Origination Form Proposed Revisions to a Standard Plans Index

Originator:	McGinnis, James	Index Number:	102-615
Date:	5/8/2024	Sheet Number(s):	4
E-mail:	James.McGinnis@dot.state.fl.us	Index Title:	MULTILANE ROADWAY, INTERSECTION WORK

ECTION	WORK	INDEX	SHEET
		102-615	4 of 5

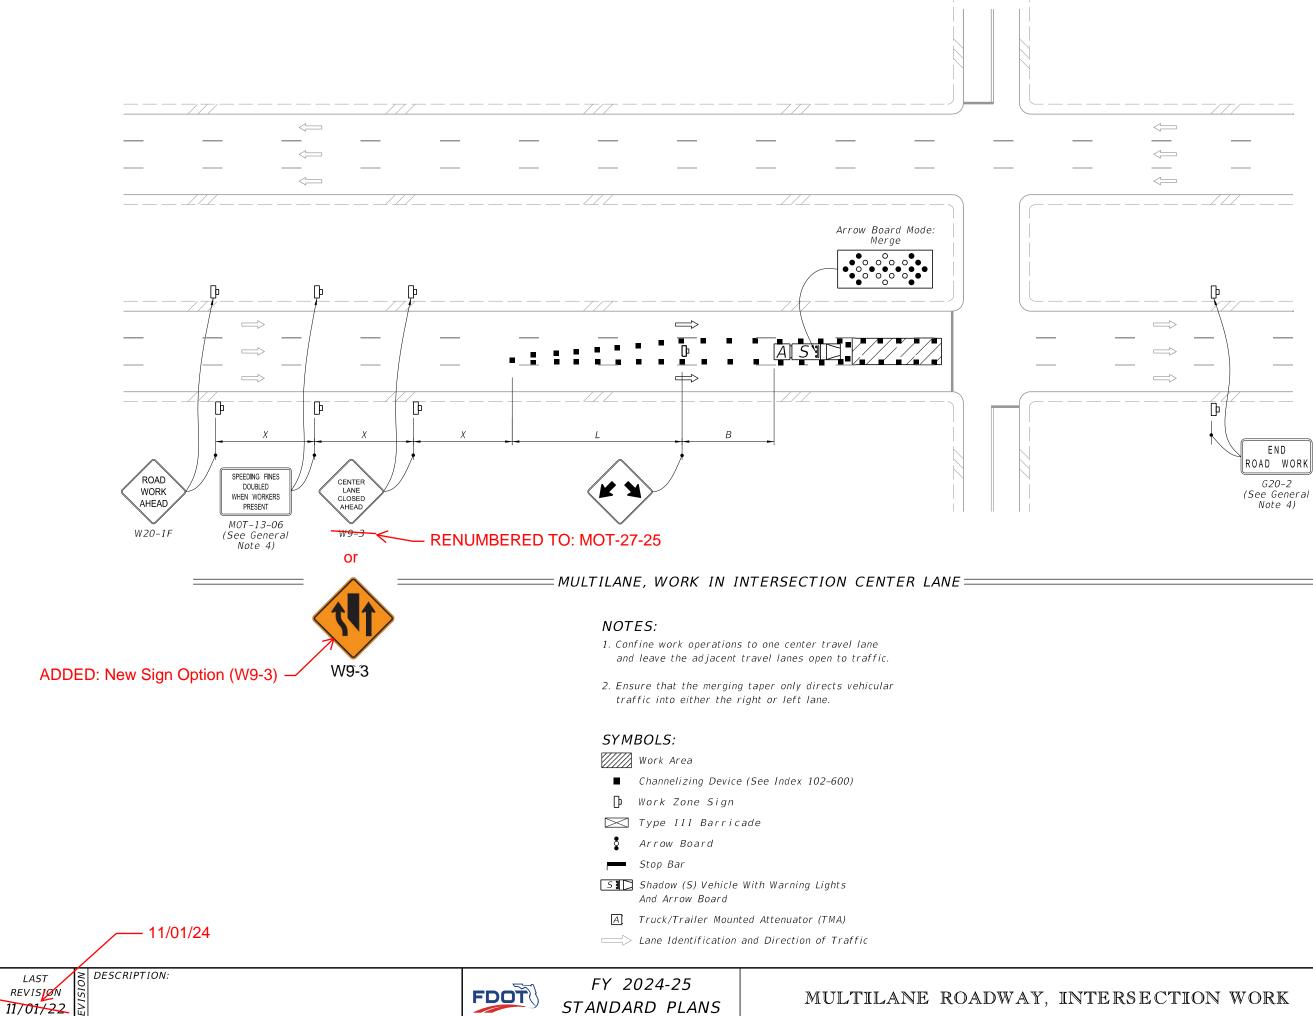
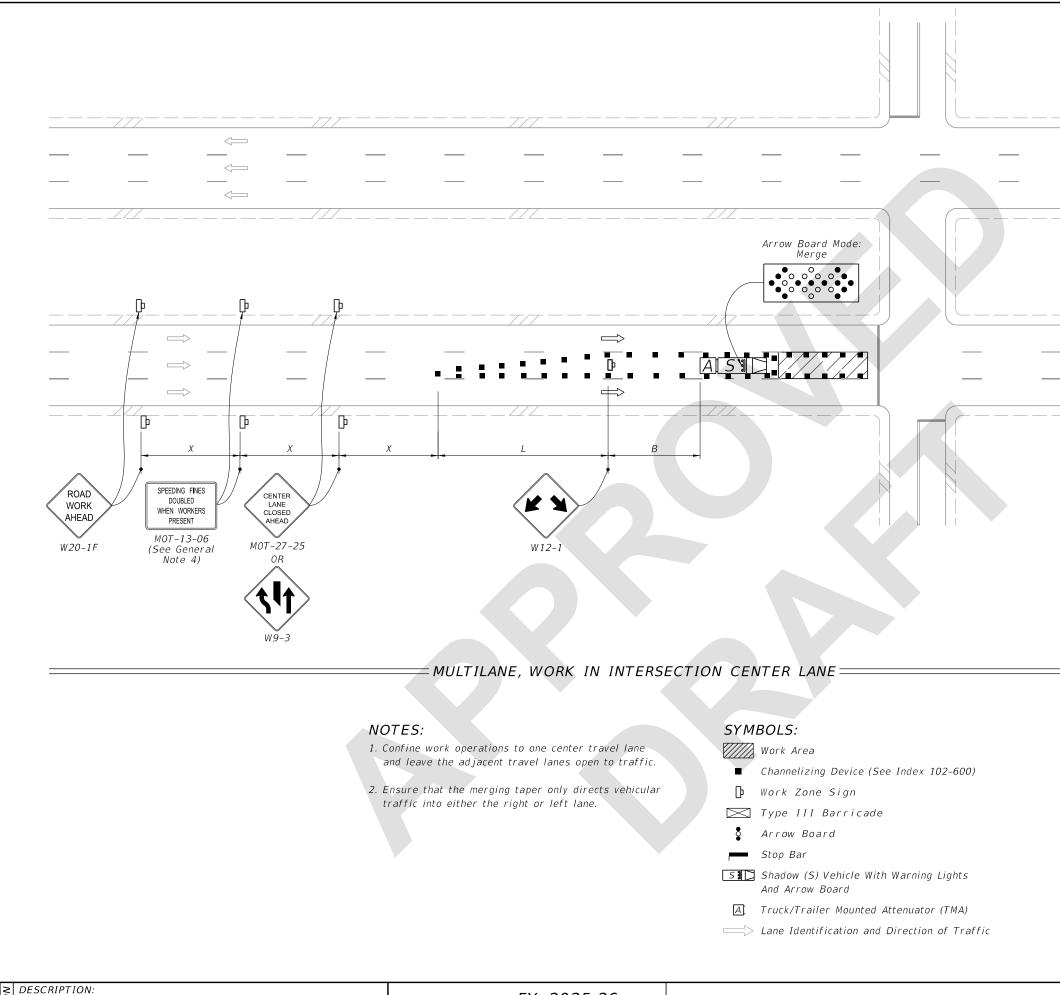
Sheet 4: Added new sign option (W9-3) under "Center Lane Closed Ahead" sign and renumbered "Center Lane Closed Ahead" sign to MOT-27-25.

New sign added to be compliant with new MUTCD 11th edition.
